# CAUI-4 C2C Transmitter and Receiver Compliance

IEEE 802.3 bm

Ali Ghiasi

Aug 22, 2013

# 10G-KR Transmitter Compliance (Comment 77, 79, 78, 81, 82, 114,

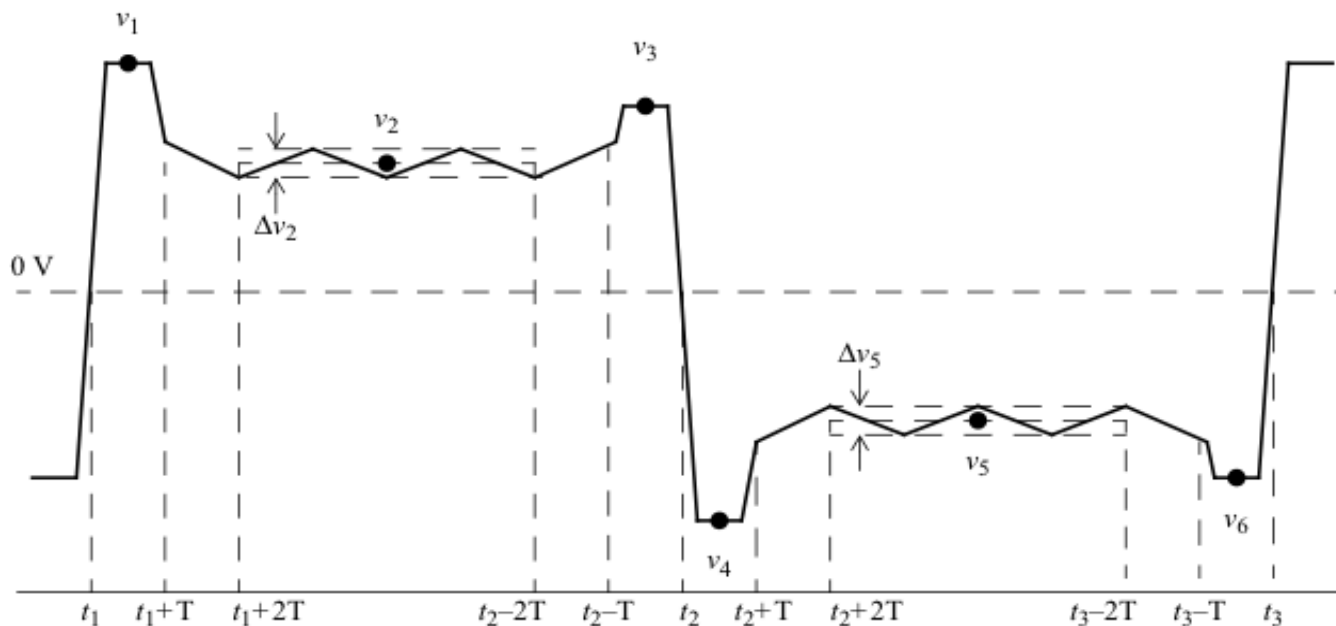
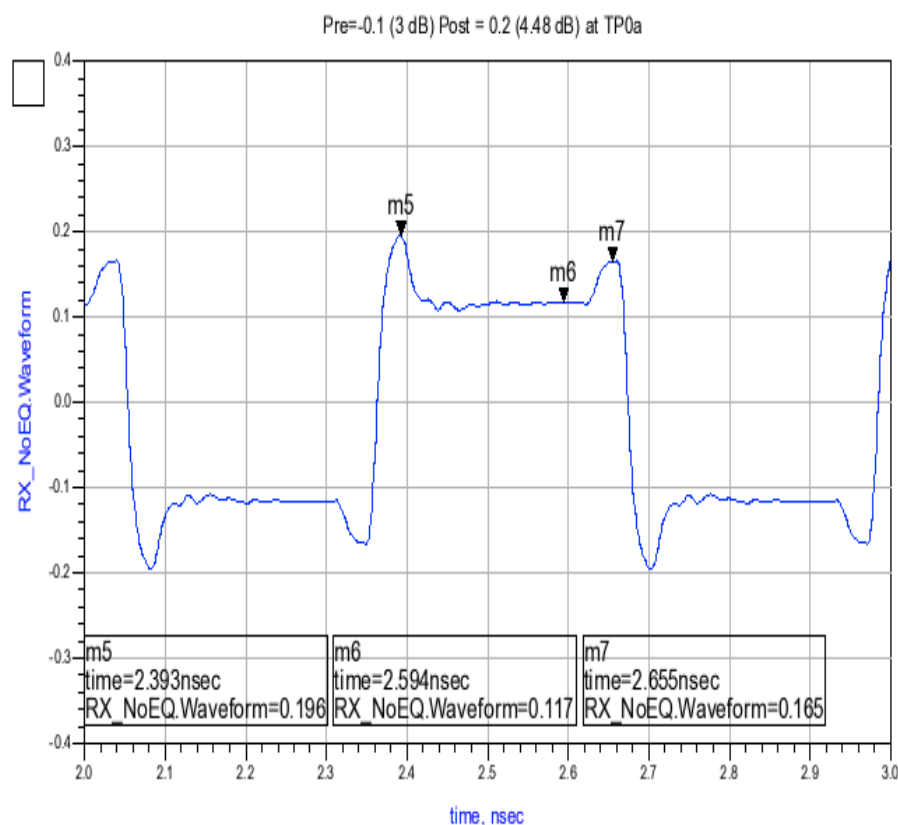
- A compliance method based on 10G-KR (CL72) but some of constrain eliminated or relaxed is sufficient for CAUI-4 applications
  - $R_{pst} = v_1/v_2 = C(1)$  post cursor = 2.0
  - $R_{pre} = v_3/v_2 = C(-1)$  post cursor = 1.5
  - $VMA = (v_2 - v_5) = 150$  mV at maximum (C1) and C(-1)
  - $\Delta v_2/VMA$ ,  $\Delta v_5/VMA$  is the VMA ripple < 10%
  - $(v_1 + v_4)/v_1$ ,  $(v_2 + v_5)/v_2$ , and  $(v_3 + v_6)/v_3 < 5\%$

# Example Transmitter Waveform (Comment 79)

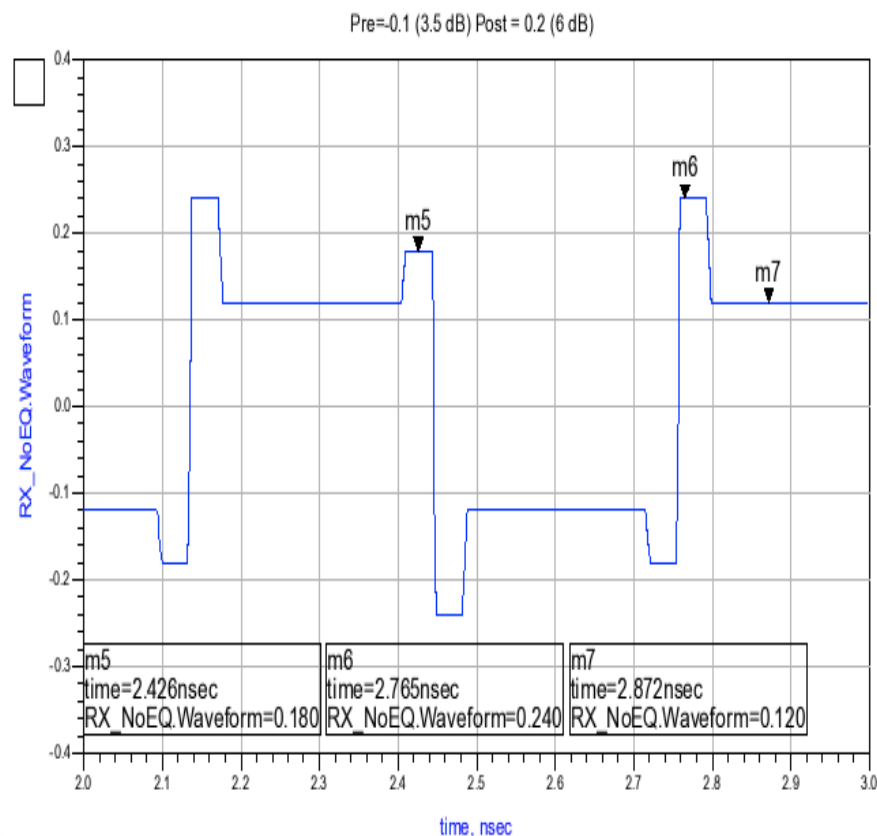
- Example TX output at device output and TP0a
  - KR approach which is consistent with CL83A and accounts for de-emphasis loss due to package/test PCB
  - The de-emphasis need to be guaranteed at TP0a in this example larger pre and post would need to meet  $C(1)=2$  and  $C(-1)=1.5$

# Transmitter Waveform (Comment 79)

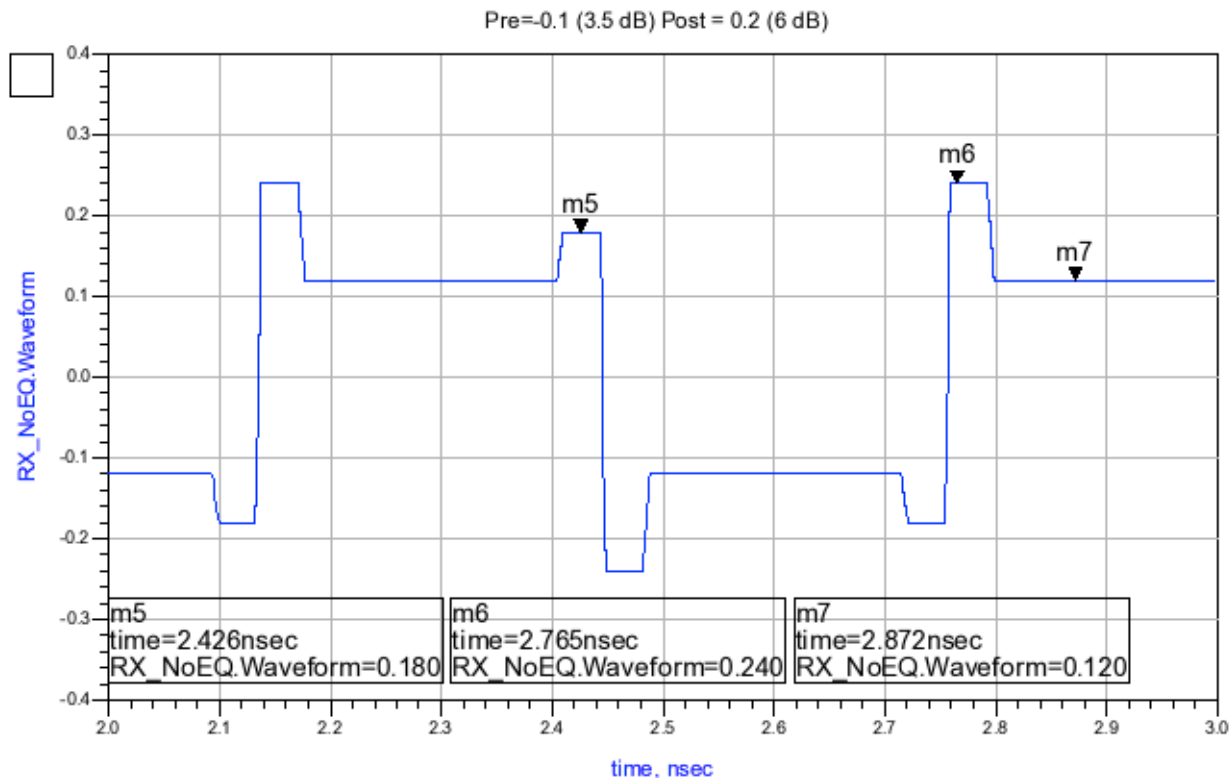
- Per KR CL72 transmitter FFE definition
  - With post cursor  $C(1)=2.0$  (6 dB) and pre cursor  $C(-1)=1.5$  (3.5 dB)
  - With previous results showing 600 mV fast transmitter and close 15 dB channel the min VMA would then be 120 mV

- Transmitter equalization pre-cursor and post cursor is measured at TP0a. The test pattern for the transmitter output waveform is the square wave test pattern with (8 ones, 8 zeros) of 83.5.10. The scope is set to waveform lock and waveform averaging is set to 32. The waveform is observed through a fourth-order Bessel-Thomson response with a bandwidth of 40 GHz.
- Post cursor is defined as ratio of
- $C(-1)=v1/v2$
- Post cursor is defined as ratio of
- $C(1)=v3/v2$
- The post cursor  $C(1)$  measured at TP0a shall be adjustable from 1 to 2.0 in 0.25 steps with variation of +/-0.125
- The pre cursor  $C(-1)$  measured at TP0a shall be adjustable from 1 to 1.5 in 0.25 steps with variation of +/-0.125

# Expanded CTLE Filters (comment 85, 87)

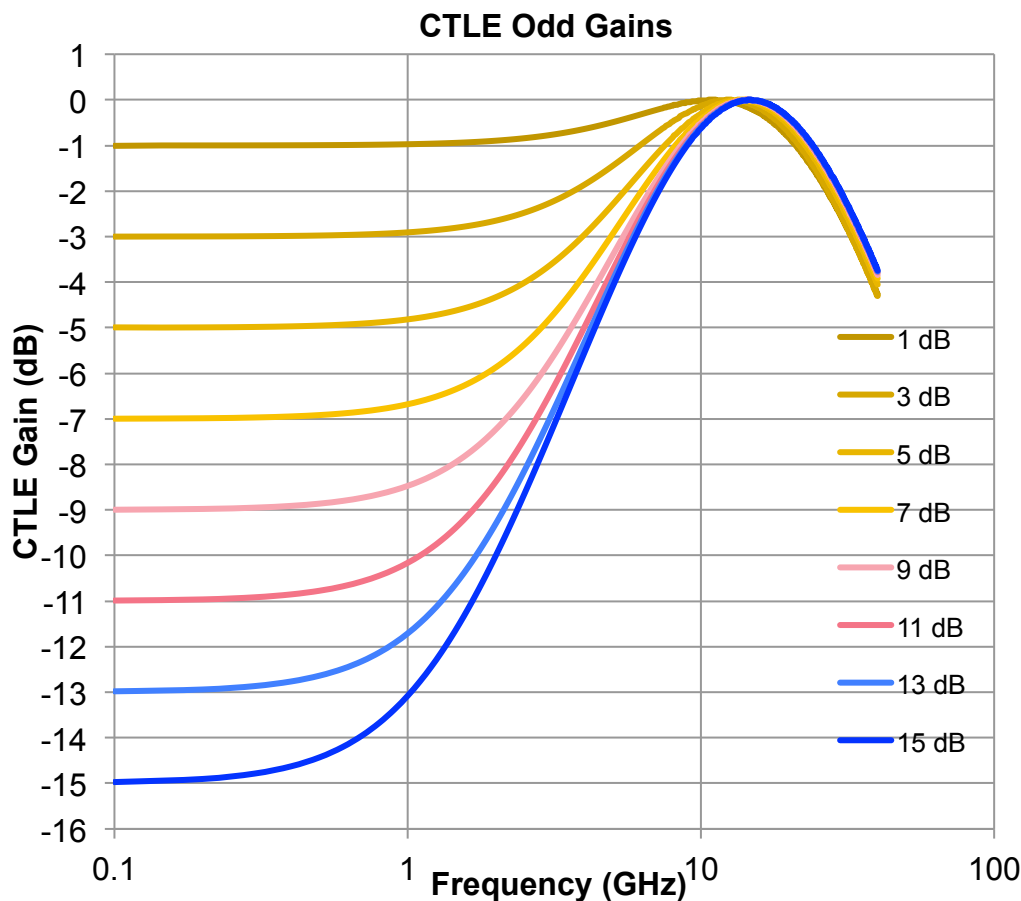
- OIF 28G-VSR and CAUI-4 chip to module were expanded from 9 dB to 15 dB
  - To make sure filter response is always passive G and Z were slightly adjusted and the new coefficient for G and Z have more significant digits
  - With the new filter coefficient the peak gain is in the 0 to -0.005 dB range
